**MODIFICATION REQUEST APPLICATIONS FOR CONCEPT PLAN
MP09_0216 AND PROJECT APPLICATION MP09_219
Shepherds Bay Redevelopment**

Shepherds Bay Redevelopment

Modification request for Concept Plan MP 09_216
and Project Application MP09_219
Submission from City of Ryde Council

Figure 3

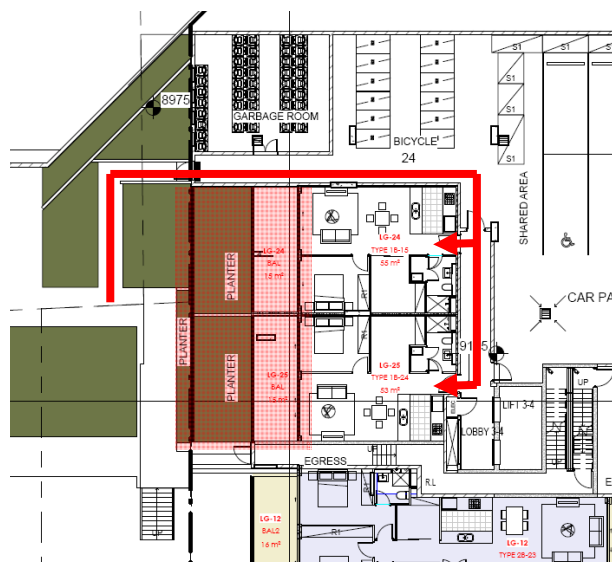
This is clearly visible in **Figures 3, 4 and 5**. The entrance to these units and their height above the public domain areas are shown in red. It should be noted that for LG 24 and LG 25, access is only achieved through the car park. This results in a disconnect with between the public domain and the proposed units. It should be noted that this is an issue for existing units UB 06 and UB 04.

- generous floor to ceiling heights,
- separate direct access to the individual units. For UB 14 - UB 18 this can easily be addressed through the lowering of the ground floor achieving an improved floor to ceiling heights,
- larger private open space areas,
- increase building separation from proposed Stage 2, and
- reduction in the number of units to provide larger more well-appointed shallower units to compensate and reduce the poor amenity.

Figure 6

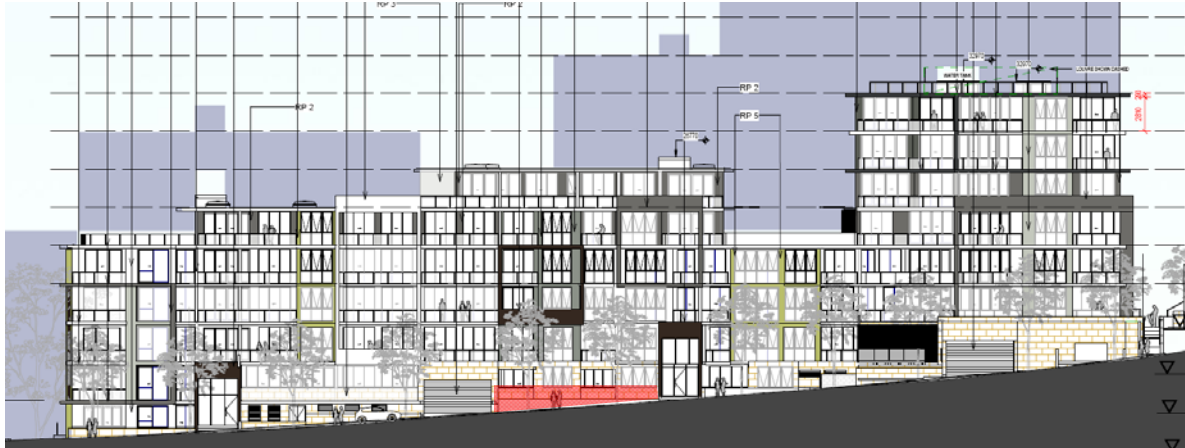
Unit	Hours of solar access	Cross Ventilated?
UB 11	1hr	No
UB 12	0hr	No
UB 13	0.5hr	No

These units also fail to provide direct address to the street and continue to fail to adequately address the public domain. This is clearly shown in **Figures 6 and 7** which clearly show the poor access and relationship to the street in red.

As per the units on the Foreshore Link, should the Department be of the opinion that the units are acceptable, the exceedingly poor amenity of these units must be compensated for by improved design and appointment. Council would insist on the following amendments:

- generous floor to ceiling levels,
- separate direct access to the individual units
- larger private open space areas,
- increase building separation from proposed Stage 2, and
- reduction in the number of units to provide larger more well-appointed shallower units to compensate for the poor amenity.

Figure 8

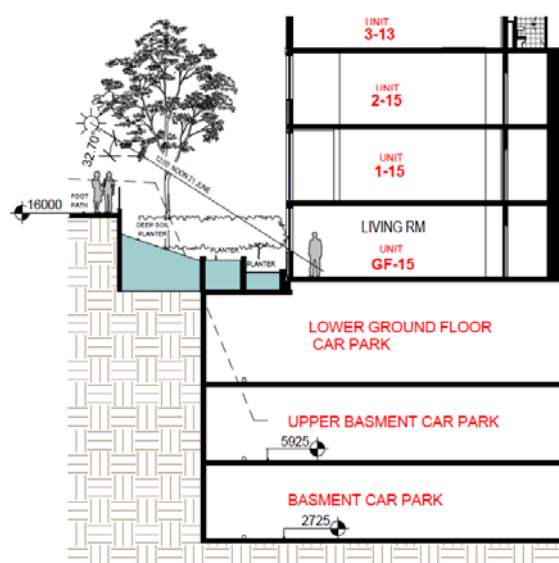
In the case of GF 15, this unit will only have 2.5hrs of solar access and is not cross ventilated. Furthermore the outlook from this unit will be to a series of raised planter boxes and Hamilton Crescent which is approximately 2.6m above the finished floor level of the unit. The solar access for this unit is dependant on no planting which will be to the significant loss of privacy for this unit. This is clearly shown in **Figure 8**.

Should the Department be of the opinion that the units are acceptable, the exceedingly poor amenity of these units must be compensated for by improved design and appointment. In the instance of these two units, GF 15 should be deleted with a significant review undertaken of the design of unit GF 14.

PROFILE - NANCARROW AVENUE (MC01)
SCALE 1:250H, 1:50V

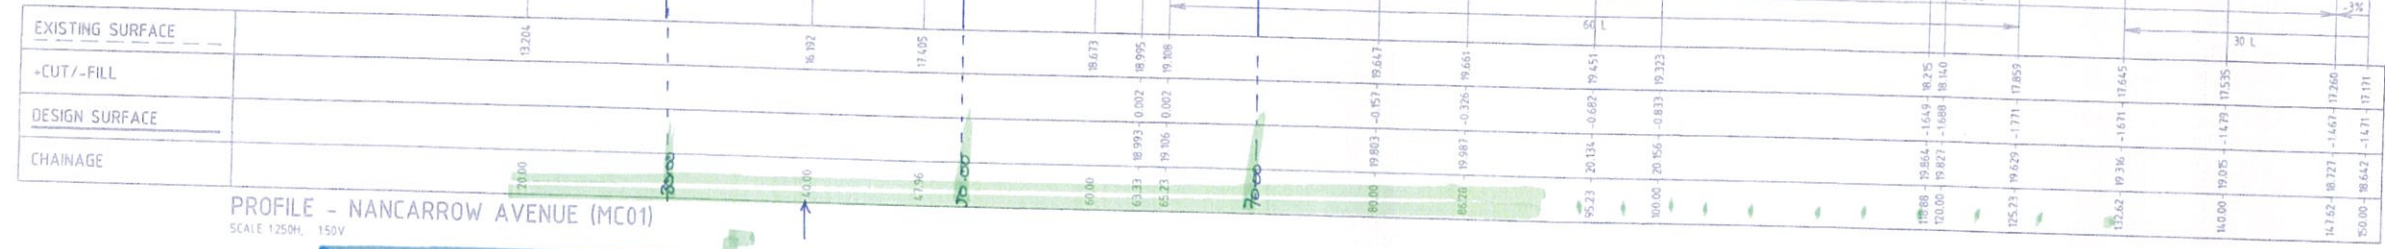
Flat surface required to avoid vehicle wheel spin.

Flat surface required at stop line of round about entry.

PROFILE - HAMILTON CRESCENT (MC20)
SCALE 1:250H, 1:50V

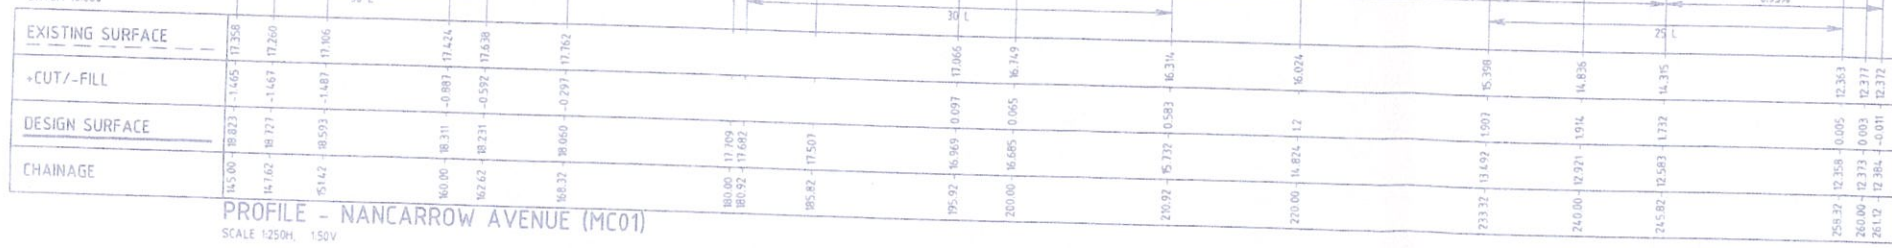
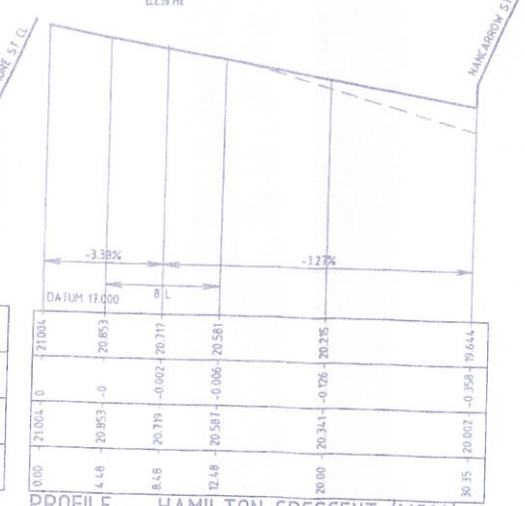
Provide all chainages (i.e. 10.00, 20.00, 30.00)

Not supported.
